Re: Major Project 08_0116 – Civil Works Stage 2 – Potts Hill Reservoir Site

Attachment A – Location & Design of Retaining Wall

Client **LANDCOM**
POTTS HILL RESIDENTIAL PRECINCT
RETAINING WALL ALONG ROAD No 4
PLAN & DETAILS

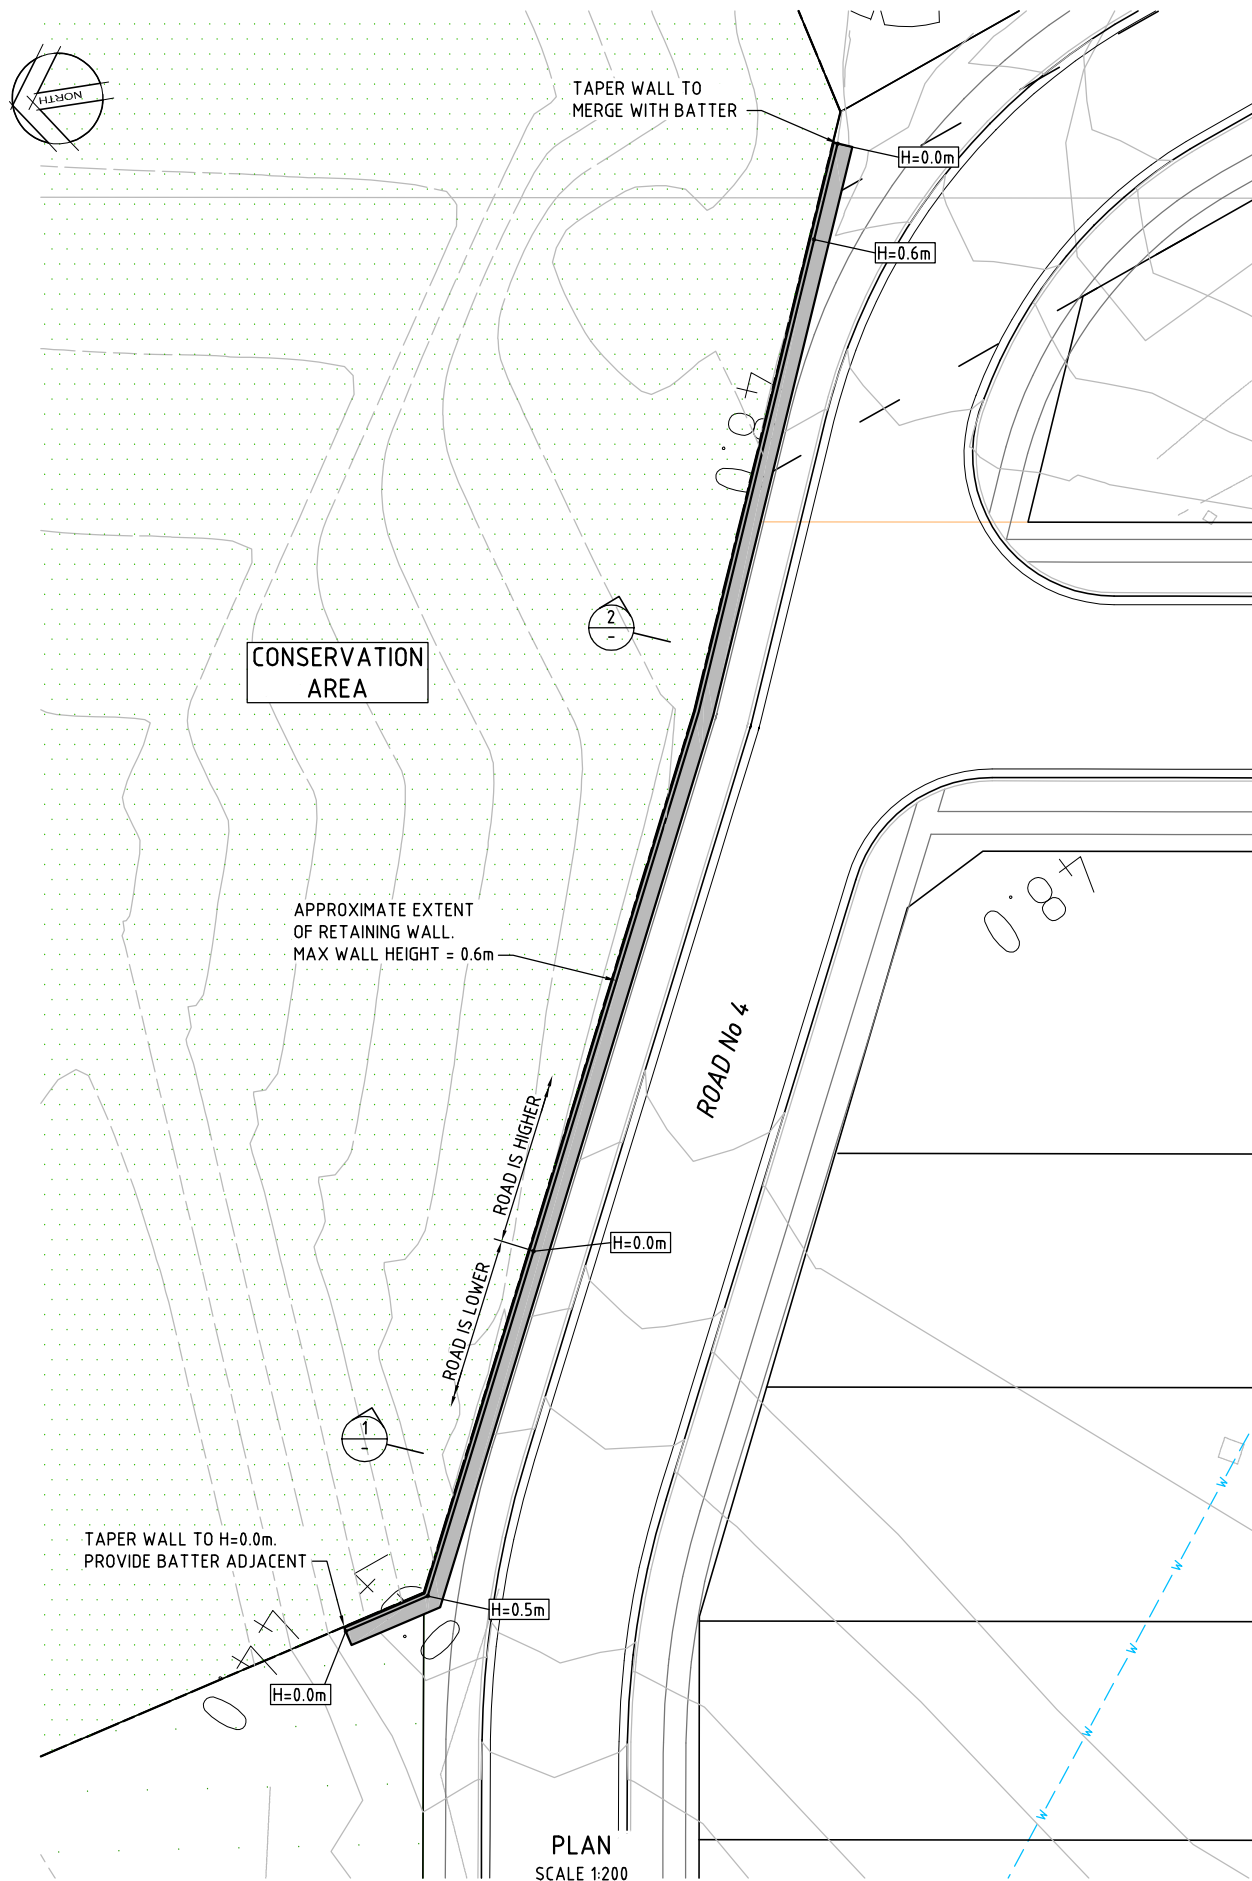
Item No.	Agenda	Comment	Action
		earthworks to clearly delineate the location of the Conservation Agreement lands, and minimise construction impacts on the conservation area. • DECCW expressed concern over the location of the retaining wall as the footing of the wall would extend into the conservation area.

Landcom has reviewed the design of the retaining wall adjacent to the Northern Conservation Area. Landcom is able to confirm that this retaining wall will be located adjacent to the Conservation Area, but not within the Conservation Area. The footing of the wall will also be located outside the boundary of the Conservation Area.

A detail plan and section of the retaining wall are attached as Appendix A.

Attachment C – Revised EEC Mapping – Explanatory Notes

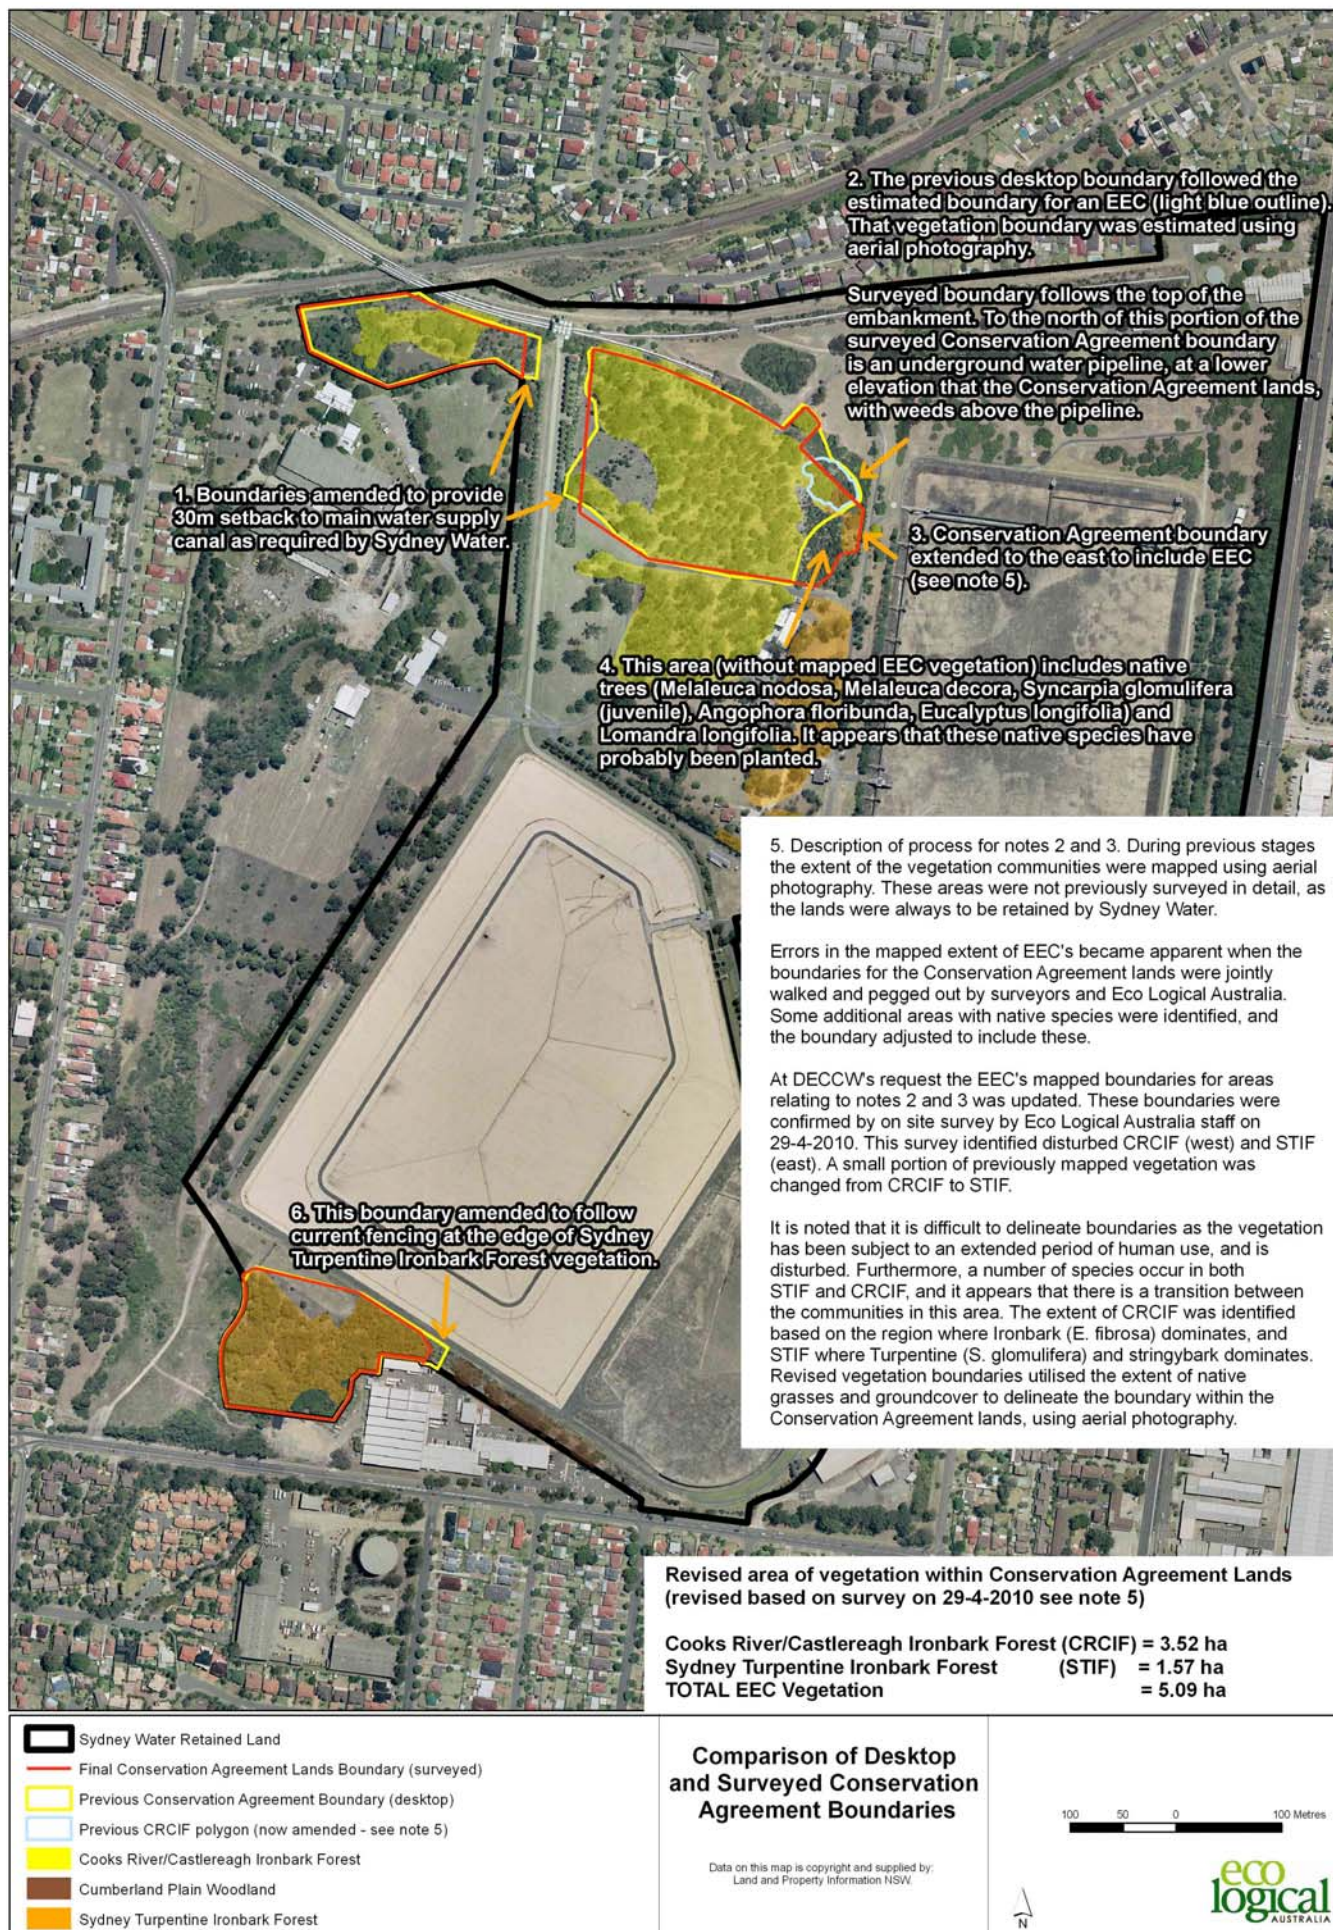
3.2	Total Area of Endangered Ecological Communities (EEC)	• Proponent noted that in working with the surveyor to accurately map the CA boundary, some differences to the extent of EECs were noted. In some areas there had been small losses in EEC area and small gains in other areas. • DECCW requested that the mapping attached to the CA (refer Appendix A) be updated to reflect the current understanding of EEC and that changes from the previous mapping be noted. • Proponent noted that this was likely to slightly increase the Vegetation Offset Ratio achieved.	Proponent to prepare 2 plans: 1. Plan showing the updated extent of EEC and CA boundaries. This plan will be included in the Final CA. 2. Explanatory plan identifying and explaining changes from previous mapping. This plan is for information only.

Landcom's Flora and Fauna consultant have updated the EEC mapping to reflect the observations made whilst delineating the boundaries for the Conservation Agreement lands with the surveyors. It is noted that to facilitate the changes to EEC boundary mapping to be as accurate as possible, an additional site visit was carried out on 29 April 2010 to verify EEC boundaries.

An updated EEC map is provided at Appendix B, and a second plan with explanatory notes relating to the changes made is shown in Appendix C. The EEC Map in Appendix B will replace the current map in the Conservation Agreement.
